La Marzocco Technical Bulletin #91 - Friday, May 23, 2014

### New filter baskets

OLD FILTER BASKET (F.3.028.GR)

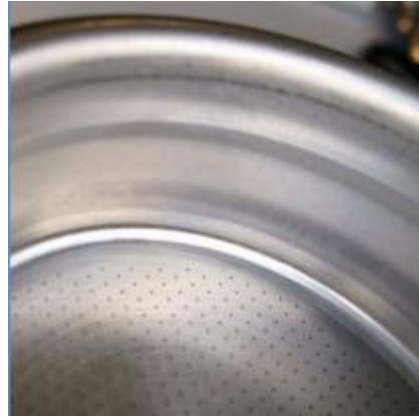
The matte finish of the new filter baskets dims the shine on the surface of the filter. The new finish will ensure the correct operating principle of Vulcano-Swift tamping since it permits Vulcano-Swift grinders, and avoids channeling along the baskets walls.

F.3.028.01 in place of F.3.028.GR (14 GR)
